Title: 2015+ N13 Cylinder Pack - Update for Excessive Lubrication Oil Consumption

Applies To: 2015+ N13 ESN: 4400000-4401769

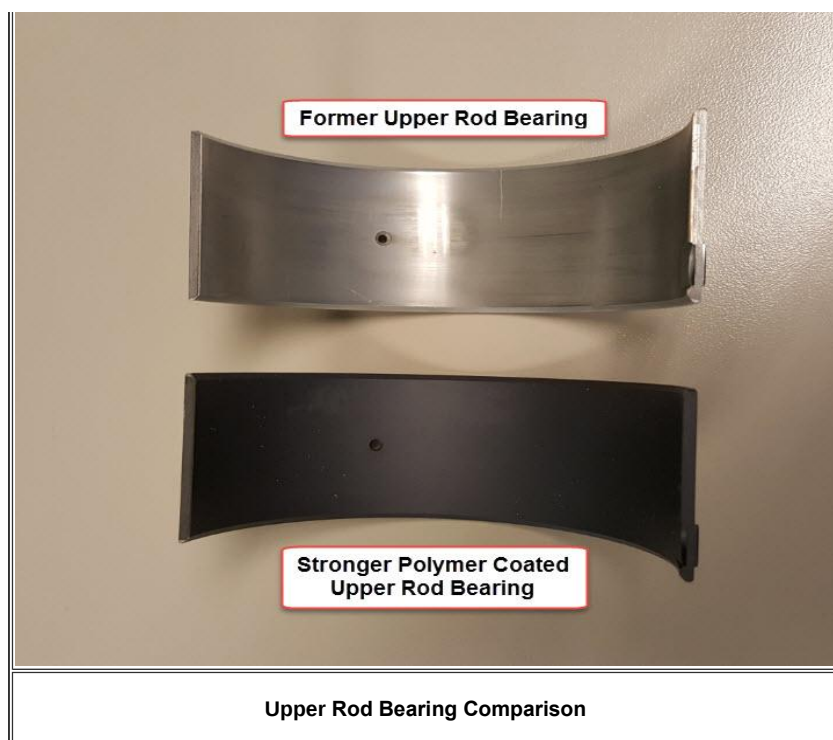
Certain N13B engines ranging with engine serial numbers **4400000 - 4401769**, can experience higher than normal oil consumption due to carbon packing and build-up within the top ring lands of the piston. An updated cylinder kit is now available to address this condition. The updated liner incorporates a removable anti-polish ring (APR) at the top of the liner. The purpose of the anti-polish ring is to scrap carbon from the top ring lands keeping the secondary and compression rings from sticking and free during engine operation.
